**Concept Plan (MP 06_0171 MOD 8)
Project Application - Blocks 1 and 4 (MP 08_0253 MOD 4)**

**Central Park, Chippendale
(former Carlton & United Breweries site)**

Director-General's
Environmental Assessment Report
Section 75W of the
Environmental Planning and Assessment Act 1979

October 2013

Figure 2: Original Project area (outlined in pink), which is to be amended to delete the building, now known as Block 4S (shown in blue), from the Project Approval

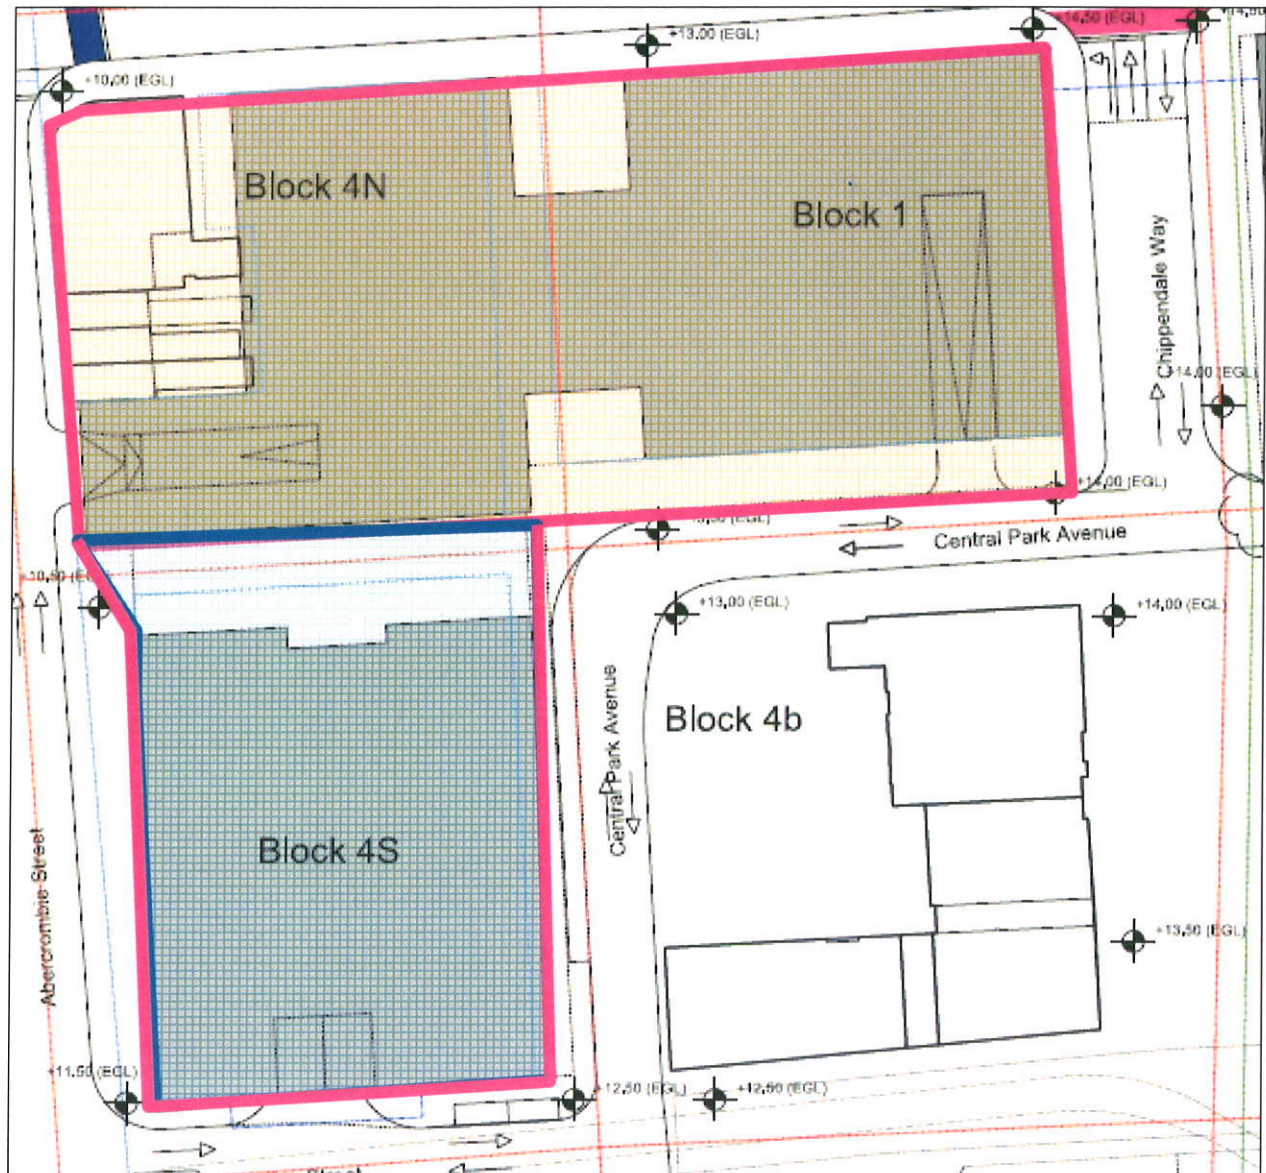
Figure 2 below provides a comparison between the Project Approval and the proposed modified scheme following the deletion of Block 4S from the project.

In relation to the modifications to the Project Approval, the department is of the view that the deletion of Block 4S from the project does not result in any negative impacts and the redesign for Block 4S is being considered under a separate SSD application.

Figure 3: Proposed Abercrombie Street elevation looking east with the approved Concept Plan dotted red (Source: Proponent's application)

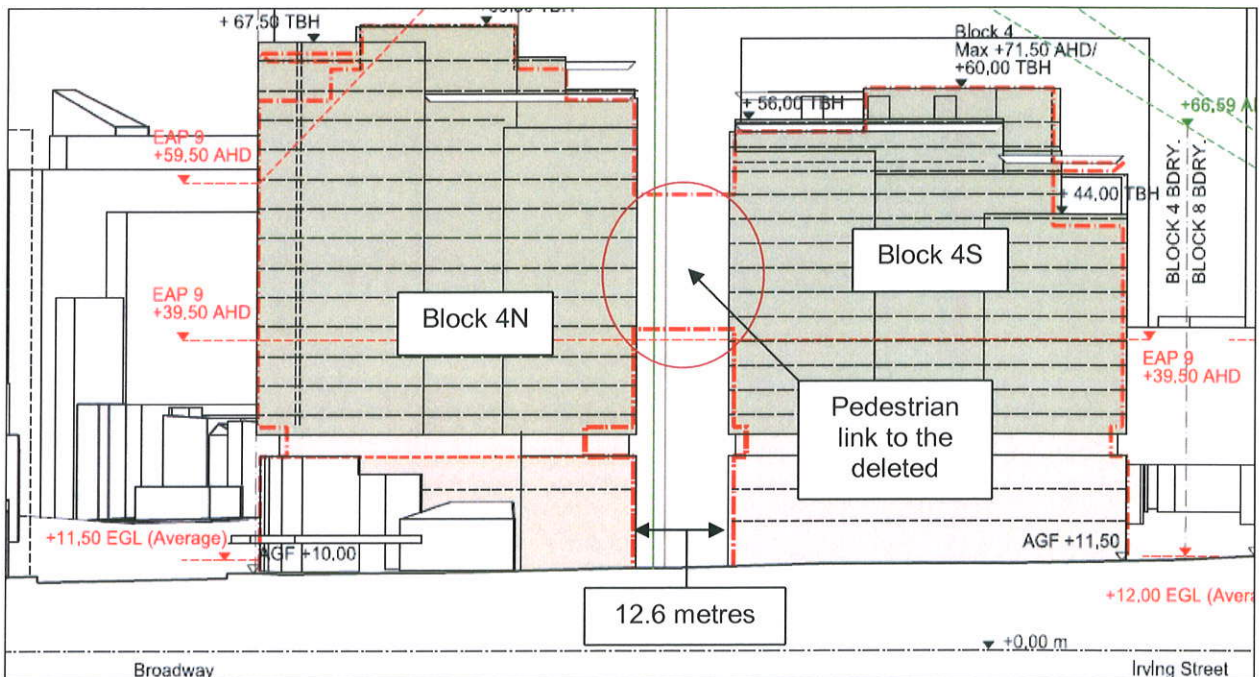
The department and Council have raised concerns with the reduction to the setback between Blocks 4N and 4S. An increase to the building separation was considered appropriate to improve the pedestrian link into the site from Abercrombie Street, encouraging pedestrian flow through the site and also assist in addressing amenity impacts of future occupants of Block 4S.

In response to the department's concerns, the proponent argues that the proposed 12.6 metre setback is adequate for the intended future occupants of Block 4S and the design of the building will be carefully considered to ensure acceptable levels of amenity and privacy are achieved for occupants. The majority of the units are proposed to be orientated east / west with some communal spaces facing towards the south.

The department is also supportive of the modified building forms however noting that a 14.5 metre separation distance between buildings 4N and 4S should be provided, instead of the 12.6 metre setback provided. Additional future assessment requirements are also recommended that require detailed resolution of future buildings.

Figure 4: Photomontage of the approved Block 1 and 4 - corner of Abercrombie Street / Broadway looking east (Source: Proponent's additional information)

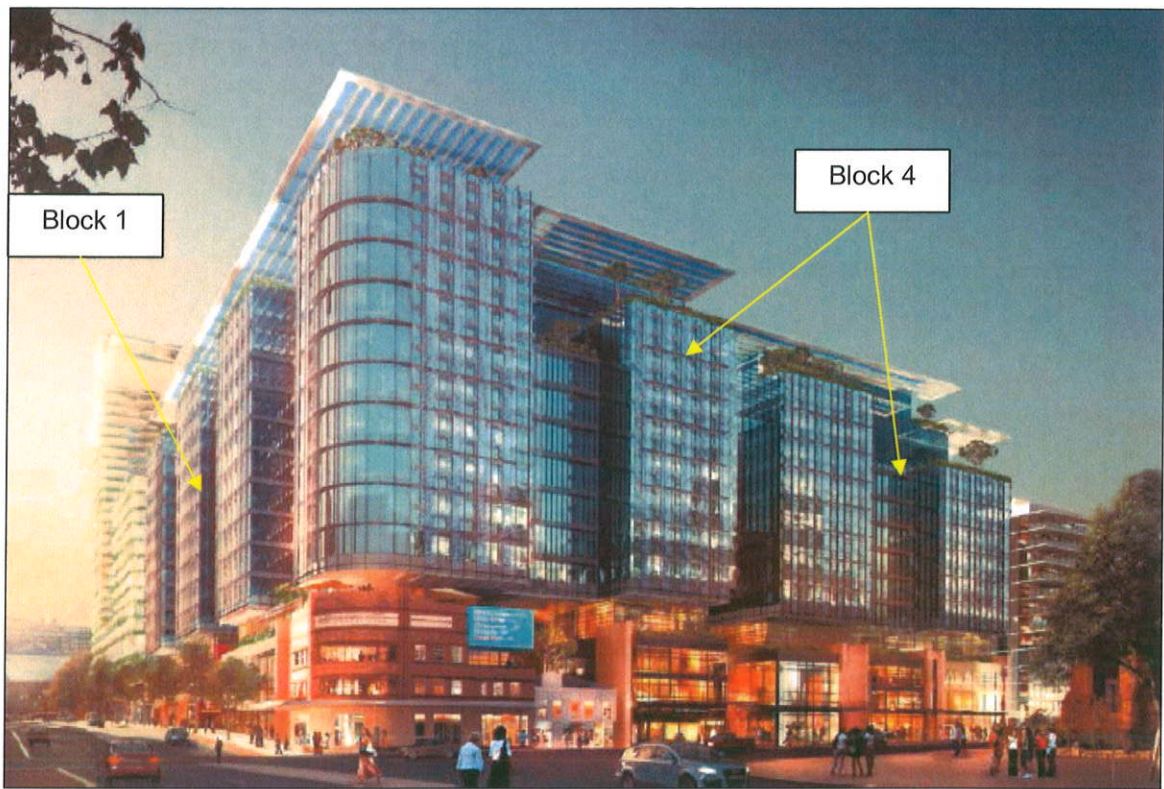
Figures 4 and 5 provide a comparison of the built form when viewed east from the intersection of Broadway and Abercrombie Street. The design of the facade to Abercrombie Street presents as two separate portions, one being the 5 storey podium area provided at a similar height to the Australian Hotel and the other being the upper 11 storey student accommodation area.

The modified built form of Block 4S has responded to the proposed use for student accommodation and includes floor plates suitable for this use.

Figure 6: Proposed Broadway elevation looking south illustrating increased building envelope area compared to approved envelope dotted red (Source: Proponent's application)

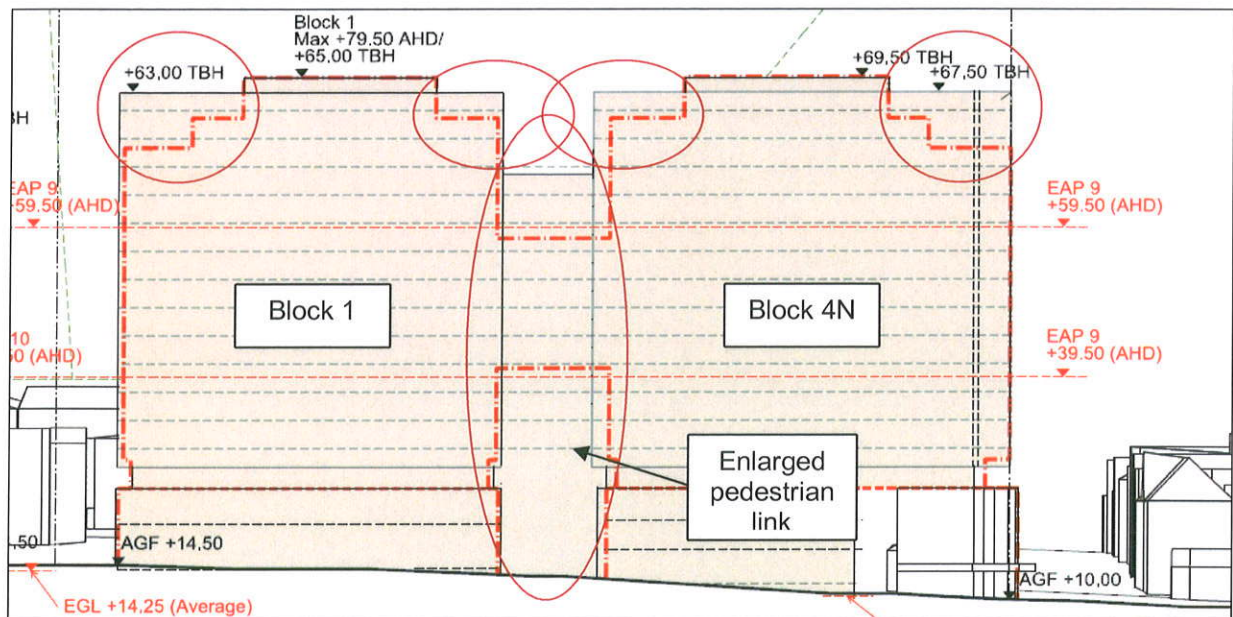
The proponent seeks to modify the building envelope along the Broadway frontage (**Figure 6**) to enable greater opportunities in the future use of the buildings, through a modification to the approved pedestrian / through site link between Levels 7 and 10 and an extension to the corner elements of the envelopes. The envelope for the link is sought to be enlarged so that it may extend from the ground up to Level 13.

While the department acknowledges the proponent's comment, the department also notes that the approved Concept Plan includes a Future Assessment Requirement requiring detailed resolution of all street sections to be determined as part of future project applications.

The other proposed additional building envelope areas along the top of the façade to Broadway (as shown by circles in **Figure 6**), are considered to have minimal impact upon the overall design of the buildings that will be considered during future Project Application modifications to the Block 1 and 4 approval. In addition, as the overall building height of the envelope is maintained, the additional building area is satisfactory.

The proponent, in any application to modify the Block 1 and 4N Broadway frontage, would therefore need to demonstrate how the building would satisfy these requirements of the Concept Plan. The department recommends a Future Assessment Requirement to ensure that the Broadway frontage is appropriately modulated and articulated and that the built form of the building does not present a continuous façade length to Broadway.

Figure 7: Setbacks to adjoining buildings should Block 1 be modified to residential and retail uses (Source: Proponent's amended application)

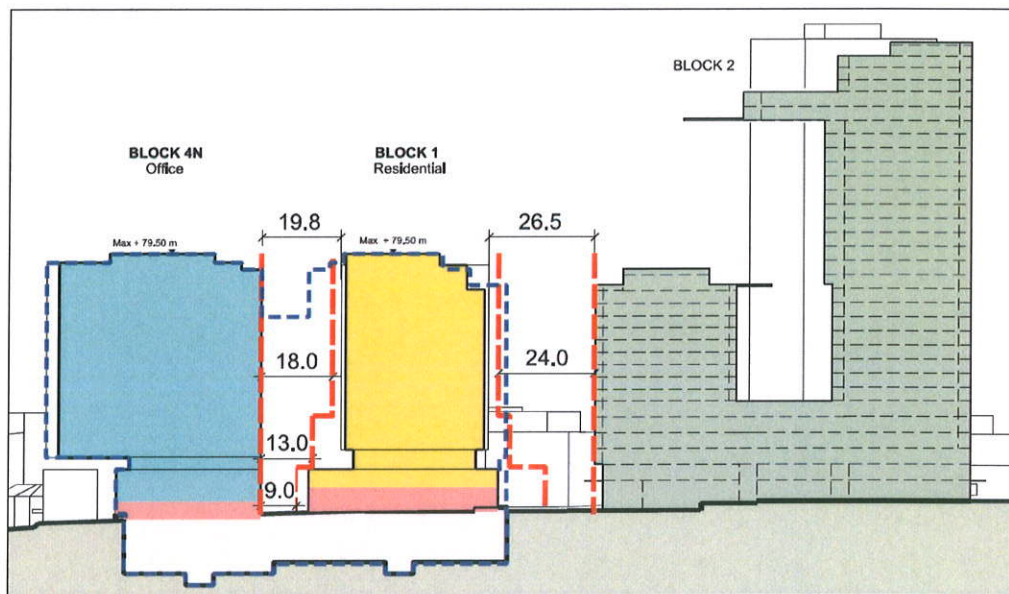
If this was to occur, the department would require the proponent to demonstrate in detail how the minimum separation distances of State Environmental Planning Policy No. 65 – Design Quality of Residential Flat Development (SEPP 65) could be achieved. The accompanying Residential Flat Design Code provides building separation requirements in order to maximise visual privacy between residential flat buildings and adjoining residences. For buildings of 9 storeys and above, a separation distance of 24 metres is recommended between habitable rooms and balconies, 18 metres between habitable rooms/balconies and non-habitable rooms and 12 metres between non-habitable rooms.

In support of the Concept Plan modification, indicative plans have been provided by the proponent that demonstrate that the requirements of SEPP 65 and the RFDC can be achieved (**Figure 7**). To ensure that residential amenity is maximised, the department recommends the inclusion of a Future Assessment Requirement to ensure that building separations are provided in accordance with the requirements of SEPP 65 between Blocks 2 and 1 should Block 1 be used for residential purposes.

Whilst the indicative width and depth are beyond that suggested by the RFDC, the department notes that the future building has similar dimensions to the residential buildings in the approved and constructed One Central Park residential development. The future building would need to be similarly articulated and apartments would need to be well designed to ensure occupants are provided with a good level of internal amenity.

Figure 8: Location of childcare centre car parking spaces within the basement car parking accessed off Abercrombie Street (shown circled) and lifts to gain access to the childcare centre on Level 3 (Source: Proponent's application)

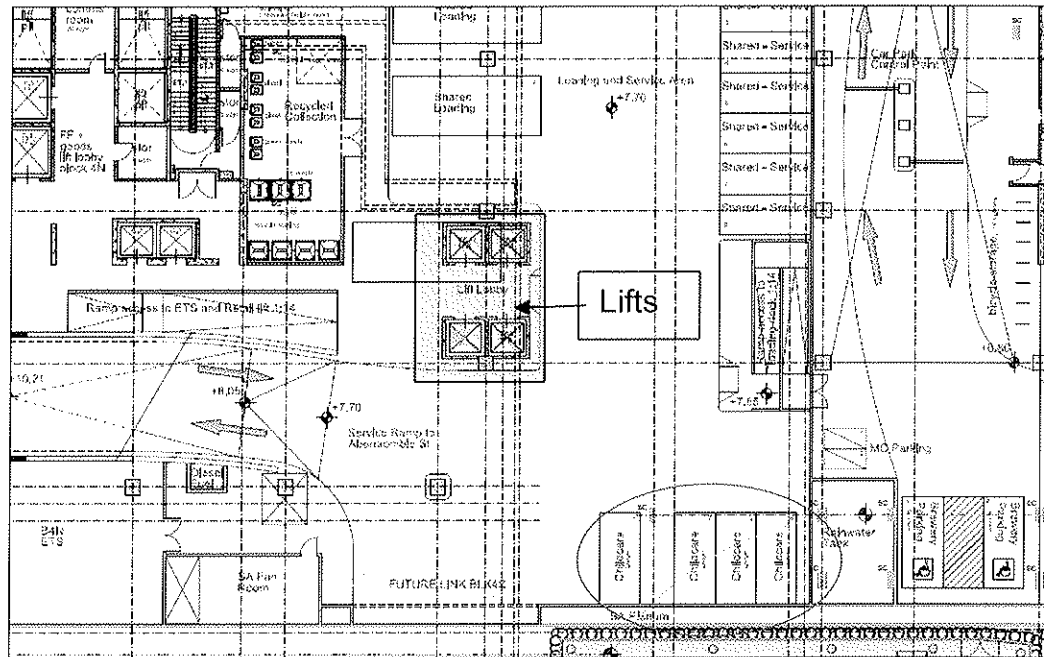
Council has raised concerns with the location of the proposed childcare centre spaces (noting that a childcare centre is approved on Level 3 to be provided within Block 4N) within the basement beneath Block 4N and the potential conflict between users of the basement area, including that between service vehicles, private vehicles and pedestrians (**Figure 8**). The future connection to the Block 4S car parking area was also raised as a concern.

The department supports on-site parking for childcare centres where appropriately located and where opportunities for conflict between vehicles and children are minimised. The department notes however the childcare centre users would need to walk across the area used to access

the service / loading dock space and is therefore concerned with the potential conflict between service vehicles and childcare users in the basement.

In addition, the department notes that the proponent has identified that there is likely to be a future connection between the basement of Blocks 4N and 4S, which in the future is to provide access to a loading / unloading area under Block 4S (temporary loading facilities are to be provided along the internal road network until the basement of Block 1 and 4N is constructed). This connection is located adjacent to the proposed childcare parking spaces that could exacerbate the likelihood of potential conflicts.

Noting the above concerns, a condition is recommended that will require the proponent to submit a final basement allocation plan to the Director-General for approval prior to the commencement of above ground works, which relocates the childcare centre parking from the basement level containing the service and loading / unloading area to a more acceptable location that provides reduced conflicts between pedestrian and vehicle movements.

Figure 9: Proposed modified signage zone (yellow square) located above the City Datum Line (shown in red) (Source: Proponent's amended application)

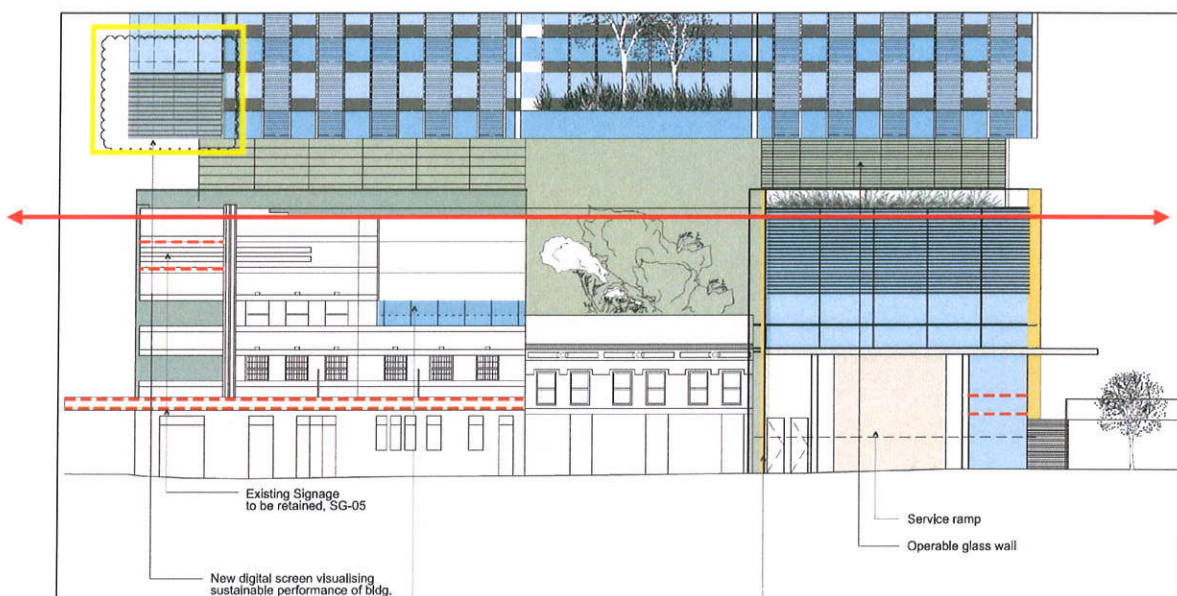
The exhibited modification to the Project Approval identified the retention of a digital screen to be provided on the Abercrombie Street frontage that was inconsistent with the requirements of the approval. Following the exhibition, the department requested that the proponent modify the exhibited plans to ensure compliance with Condition A10(b), which states:

As a result of the department's request, the proponent provided modified architectural plans in the amended application, **Figure 9**, which illustrates that the proposed digital screen has now been located above the City Datum Line, which satisfies the requirements of Condition A10(b) and as such Condition A10(b) is recommended to be deleted.

Notwithstanding this, the Project Approval includes a requirement that the approval only consents to the signage zones but does not approve the structure, content, illumination or materials. Further applications will need to be submitted to Council for assessment under Part 4 of the EP&A Act.
